METROPOLITAN GOVERNMENT OF NASHVILLE AND DAVIDSON COUNTY

STAFF RECOMMENDATION 1318-1326 6th Avenue North April 16, 2014

Application: Alterations, New construction-addition and infill
District: Germantown Historic Preservation Zoning Overlay
Council District: 19
Map and Parcel Number: 08209005200, 08209005300, 08209005400
Applicant: Justin H. Lowe/ Centric Architecture
Project Lead: Robin Zeigler, robin.zeigler@nashville.gov

Above: 1326 6th Avenue North today
Below: 1326 6th Avenue North in 1975

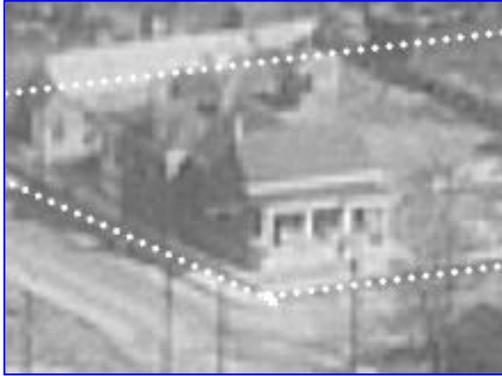
removal will not require damaging the historic building, partial demolition meets section 7.0.

Alterations for E1 (1326 6th Avenue North): (See pages 2-7 of the plans.) Other than removal of non-historic elements (see partial demolition) the only other alterations will be the replacement of windows and doors and the front porch, all of which are not original and replacement of materials

on the side dormer. New windows will be wood double-hung and the doors will be solid wood. Windows and doors will retain their original locations and dimensions. Porch posts will be wood and the existing concrete floor will be retained. The roof will be a membrane or metal standing seam, color unknown. The roof of the house will be asphalt shingle of a warm grey or brown color. The brick will be repointed. Synthetic siding will be removed from the dormer and replaced with fiber cement lap siding and trim. Staff recommends final review of windows and doors, roof colors and types prior to their purchase and installation, review of the mortar type and color and that the lap siding have

a maximum of a five inch (5") reveal. The design of the new porch is based on the early photographs. Originally the building likely either did not have a front porch or included simple columns rather than the post-and-pedestal design seen at the time of the photographs. It would be appropriate to either remove the porch or reconstruct the current configuration. The applicant has chosen the latter. The project meets sections 1.1.5, 1.5 and 1.6.2.

E1 - DEMO PLAN 1/8" = 1'-0"

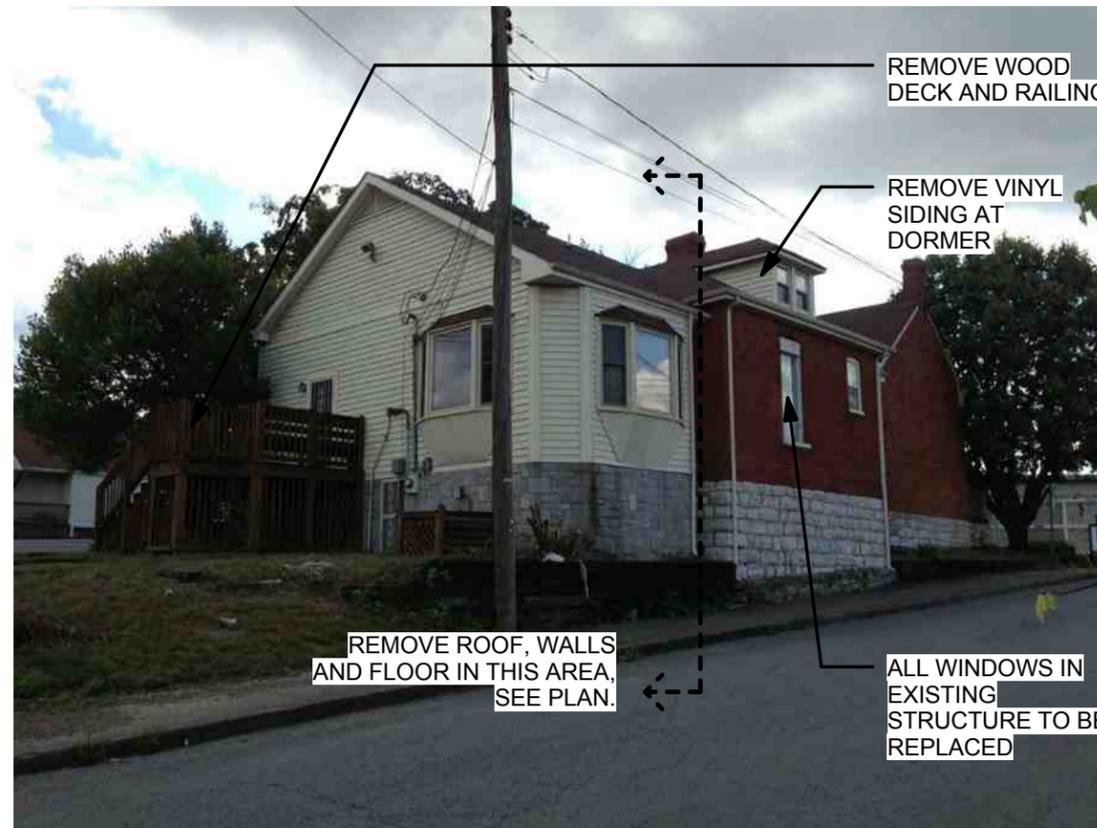
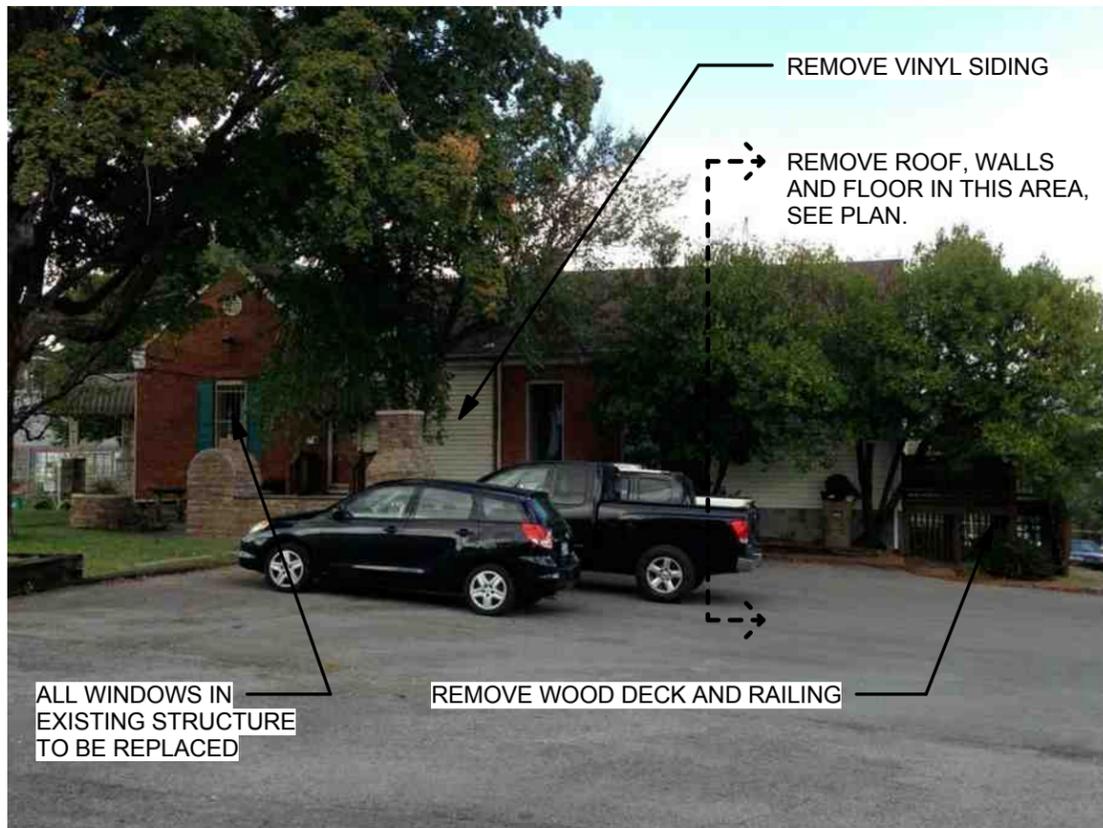
Partial Demolition for E1 (1326 6th Avenue North): (See pages 2-7 of the plans.) Partial demolition will include elements that have been added to the building in recent years such as bars on the windows, awning, dentil moulding, wrought-iron and wood columns and railings, shutters, and faux stone veneer. A recent rear addition will also be removed and replaced with a new addition. Since the existing addition and other features proposed to be removed are not historic and their

N1 - 6TH STREET ELEVATION 1/8" = 1'-0"

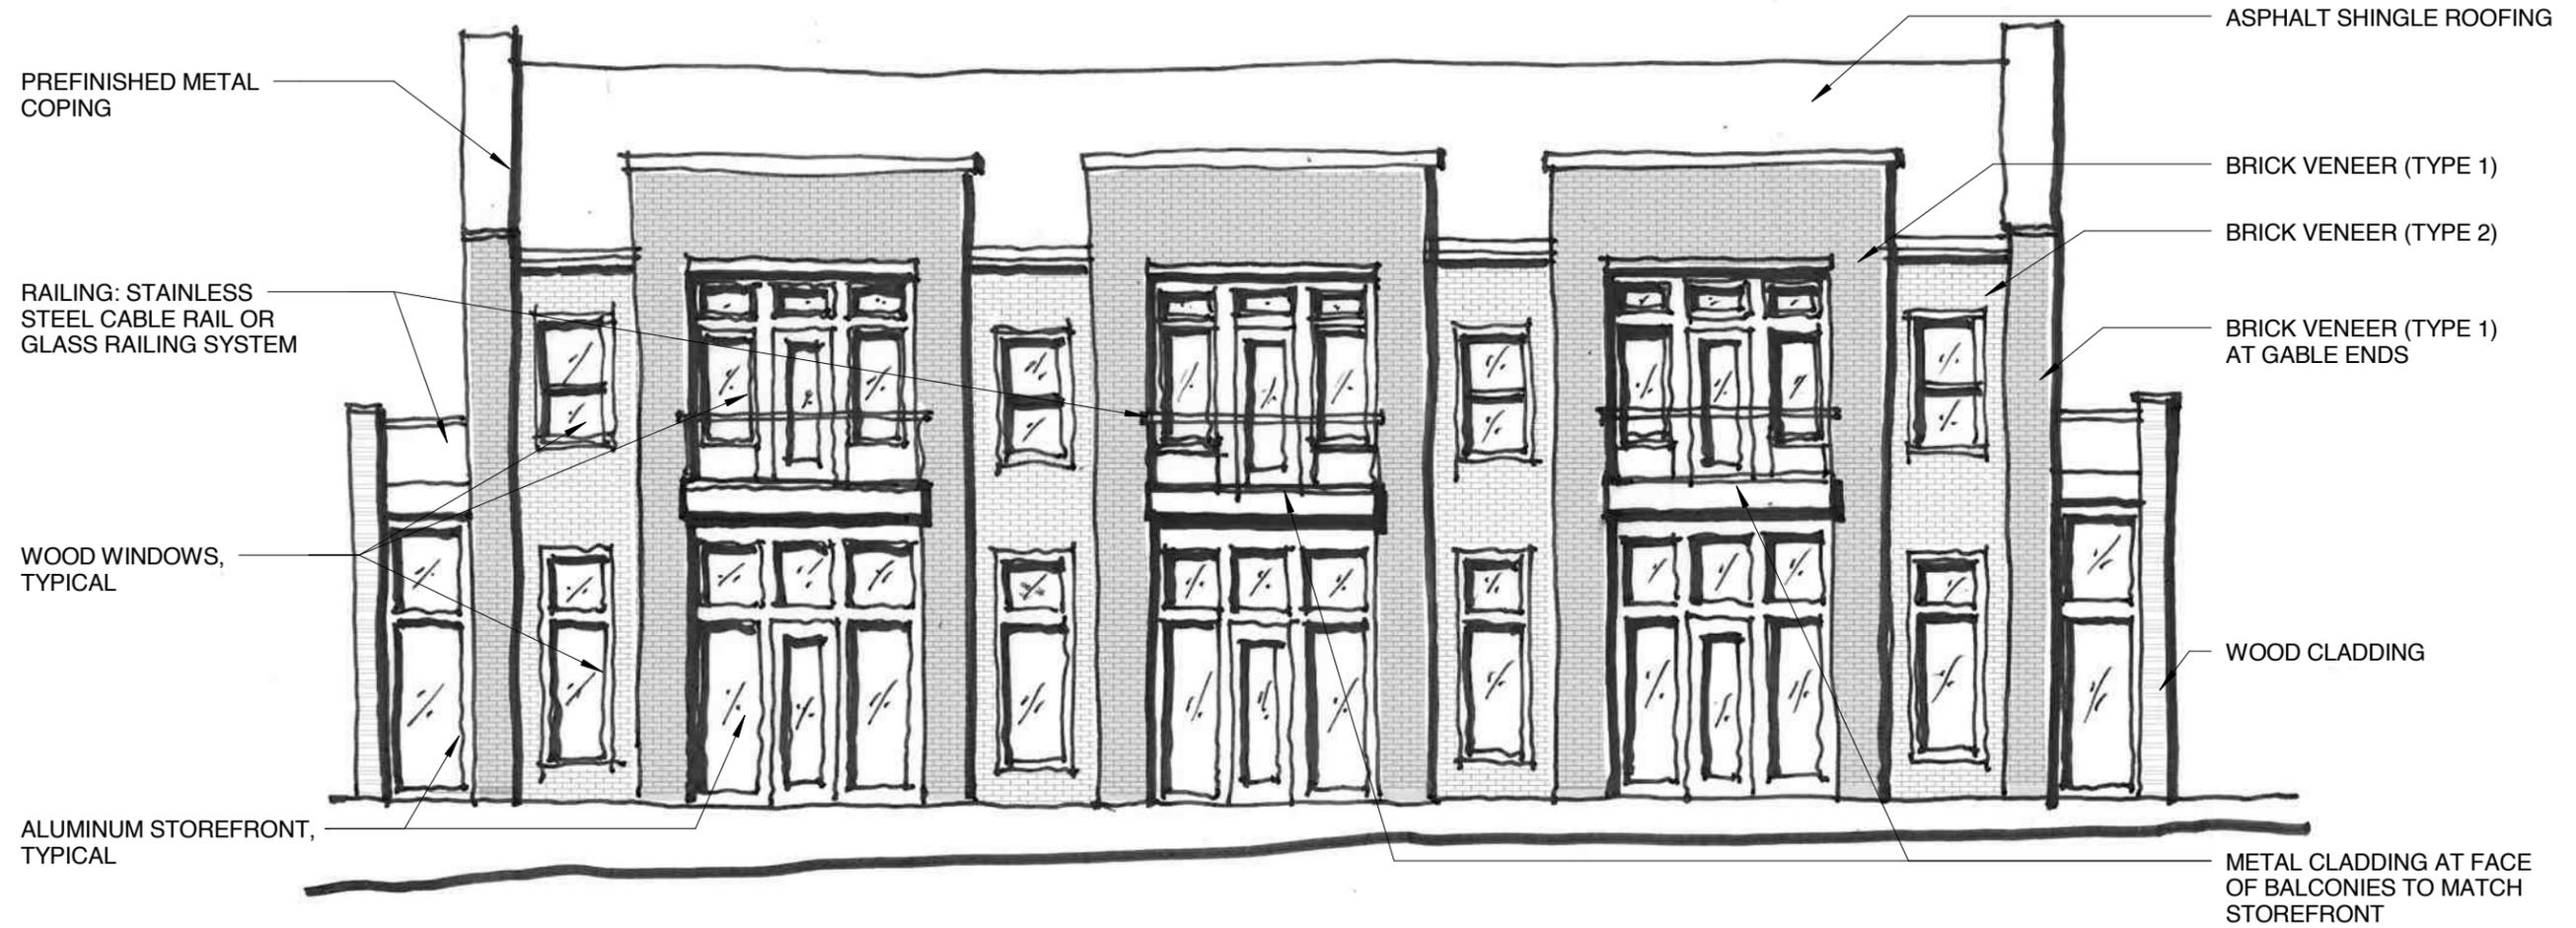
The railings are proposed as steel cables or a glass railing system to minimize their impact since upper level balconies are not typical of the overlay. The floor of the upper level balcony will be clad in metal to appear as metal canopies above the entrances. Windows will be either metal storefront windows or wood casement windows. The roof is asphalt shingle but the color was not indicated. With the condition that staff provide final review of materials, the project meets section 2.4.

- Final materials be approved by staff;
- All windows and doors are recessed a minimum of two inches (2") from brick walls;
- The front balconies of building N1 do not extend beyond the porch of E1;
- Staff provide final review of mortar types, color and texture for the repointing;
- Staff provide final review of exterior lighting; and,
- Applicant submit a new permit application for any signage.

E2 - DEMO PLAN - GROUND 1/8" = 1'-0"

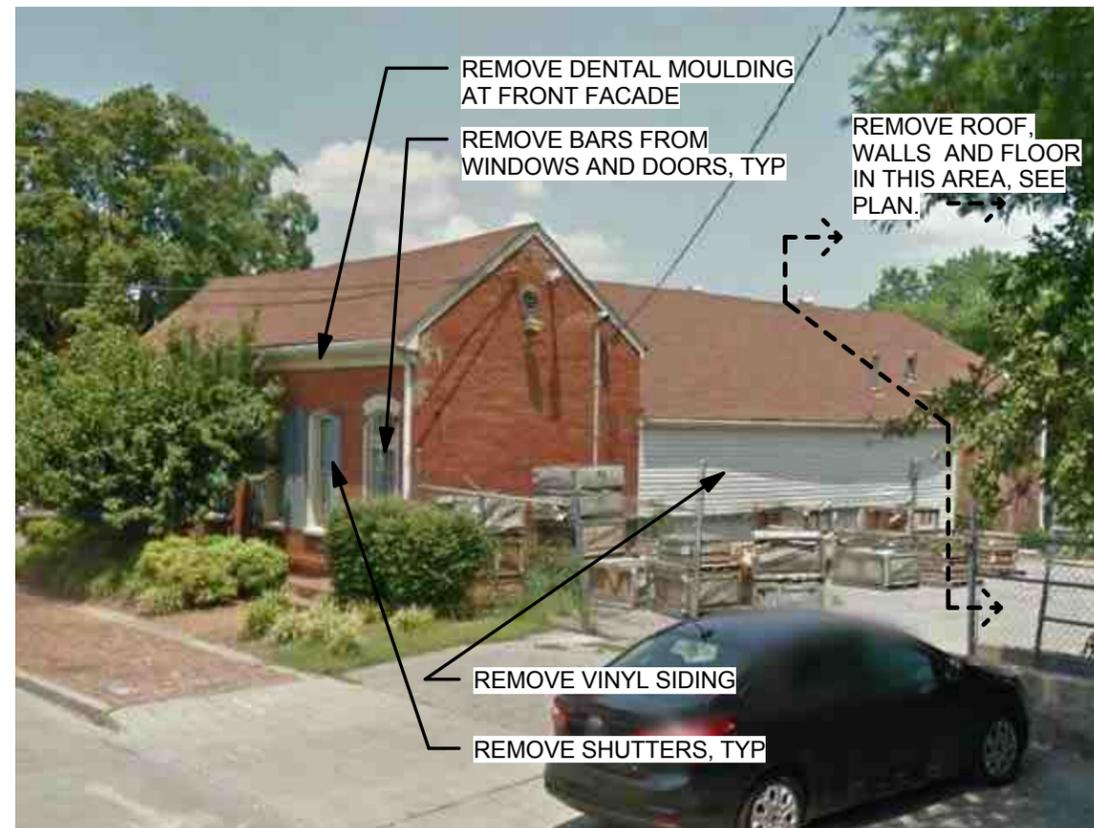
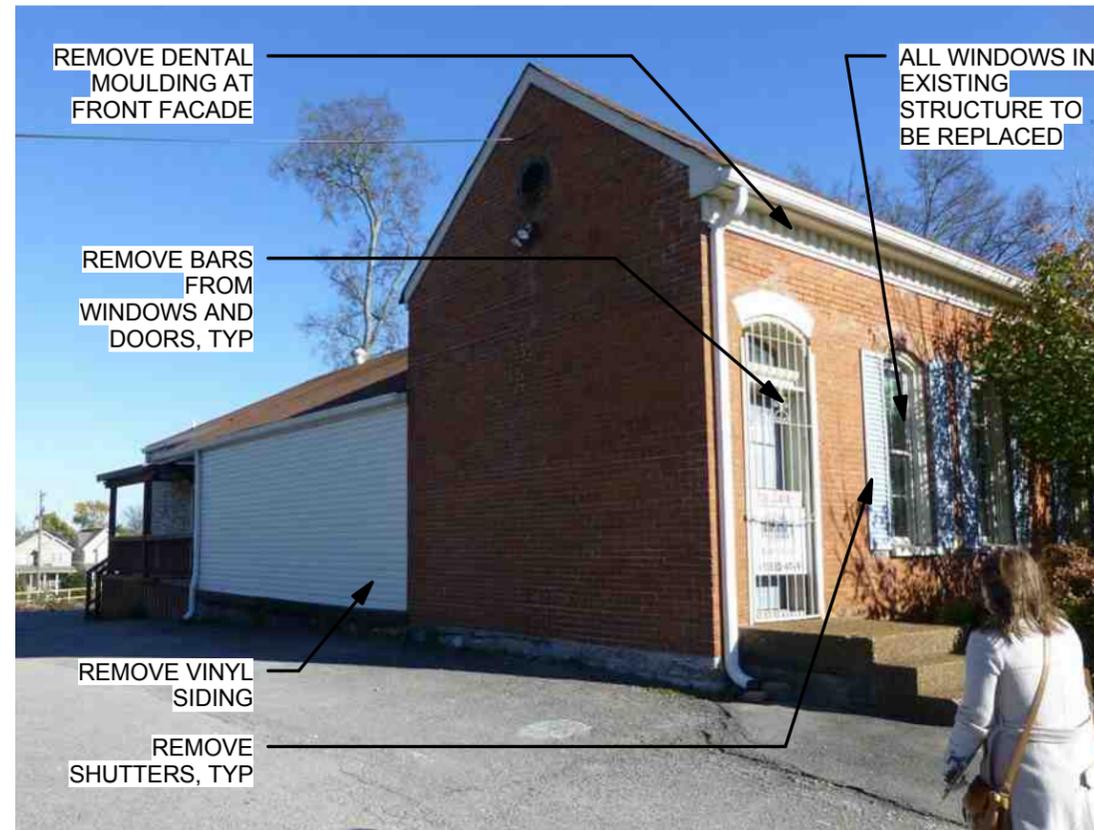
Partial Demolition for E1 (1318 6th Avenue North): (See pages 14-20 of the plans.) Partial demolition will include elements that have been added to the building in recent years such as bars on the windows, dentil molding, and shutters. Partial demolition also includes removing the siding enclosing rear side porches. Since the features are not historic and their removal will not require damaging the historic building, partial demolition meets section 7.0.
